# BLUEWAVE

**Subject:** Response to Planning Board/PARE Corp Comment for the Special Permit Petition and Site Plan Review for BWC Wades Stream, LLC LSGMSPI

WSP USA Inc. (“WSP”) and BWC Wades Stream, LLC (“BlueWave”) received the Worthington Planning Board/PARE Corp letter dated 5/19/2026 related to the above referenced project. WSP and BlueWave have prepared the following responses and supporting documentation for consideration by the Board.

**Figure 1      Glare Model PV Array Areas and Receptors**

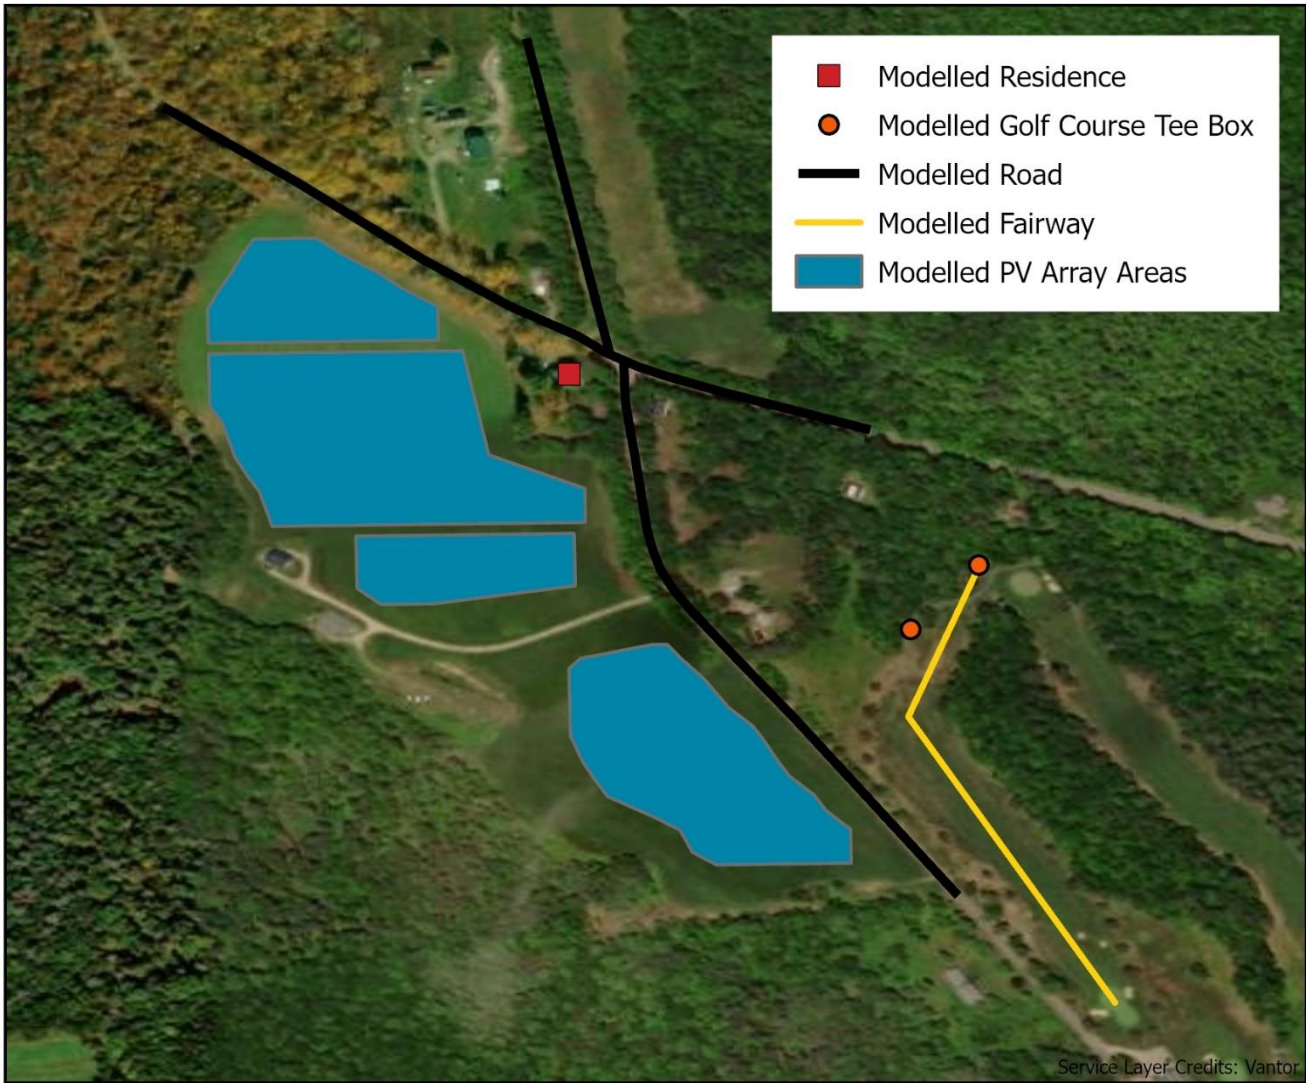
- a. Please provide the specification sheet for the proposed solar panels, racking system, tracker system and other equipment, being sure to include information about potential glare.

- b. Please provide results of any glare studies you are aware of involving similar equipment.

**BW Response: See attached, Appendix C, for project specific glare analysis based on proposed equipment. No glare is predicted for the residence of the abutting property, the neighboring golf course, or the adjacent roads.**

**BW Response: See attached, Appendix C, for project specific glare analysis.**

Appendix D: BWC Wades Stream, LLC Approximate  
Geotechnical Test Pit Location Areas

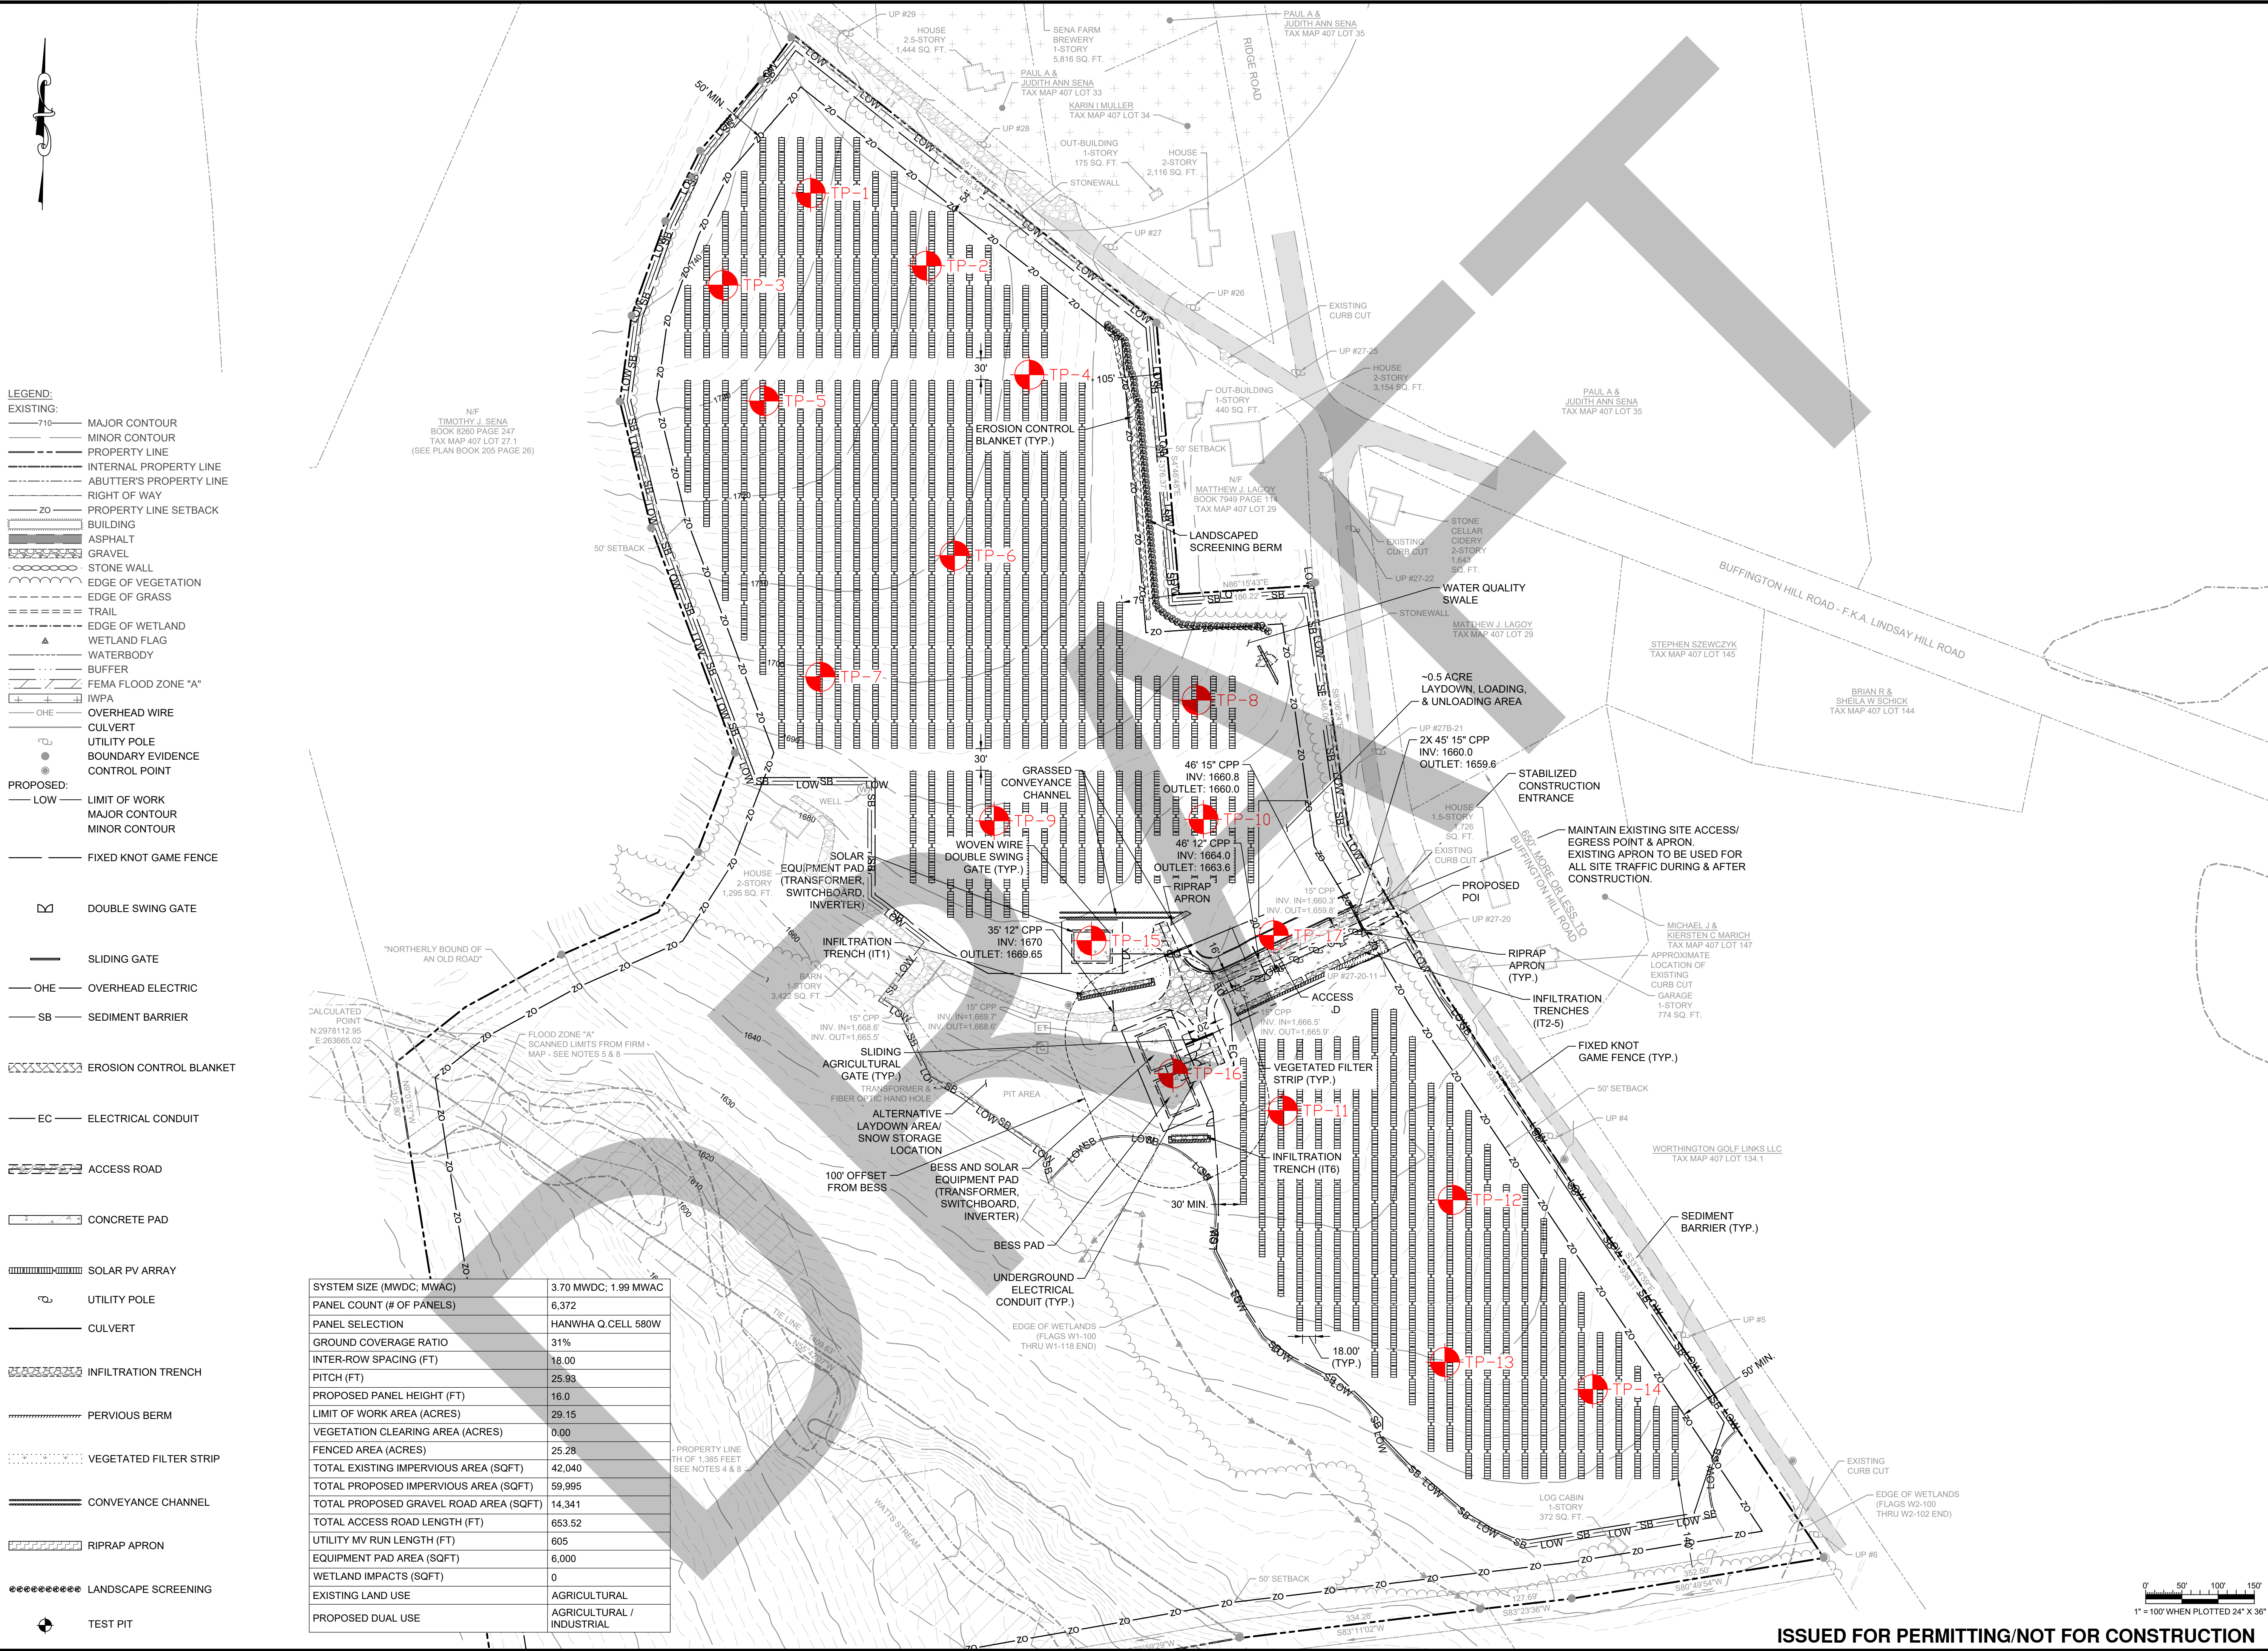
- a. Please provide the purpose and results of the Geotech or test pit investigations in evidence during the site visit on April 24, 2026. Please include a map or schematic showing the approximate layout of the test pits.

**BW Response: The purpose of a geotechnical investigation is to analyze subsurface conditions to support the future construction design of the proposed project. The site field work for this analysis has been completed. The geotechnical report and soil laboratory tests have not been finalized. The approximate test pit investigation locations have been included in this response, Appendix D.**
